TO: Mercedes-Benz Dealer Principals, General Managers, Sales Managers, Service Managers, Parts Managers	FROM: Gregory Gunther, Department Manager, Vehicle Compliance and Analysis, Engineering Services
RE: Recall Campaign Launch Notification 2019040025 Check Steering Boot MY18-19 S-Class, S-Class Coupe (222, 217)	DATE: April 19, 2019

Campaign No. 2019040025, April 2019

SUBJECT: **Model S-Class and S-Class Coupe vehicles (222 and 217 platforms)
Model Years 2018-2019
Check and Rework Steering Boot**

Figure 6

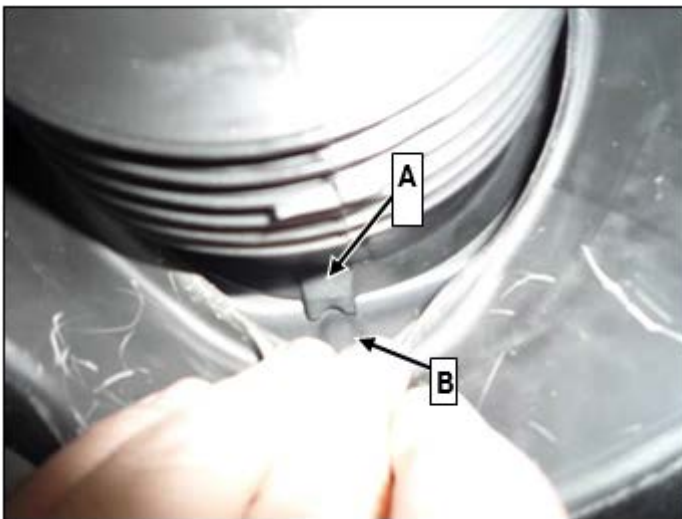
i Turn steering boot far enough until the marking on the steering boot **(A)** matches the marking on the firewall **(B)** (**figure 6**).

i The folds of the boot must not be deformed.

1. Correct installation position of steering boot.
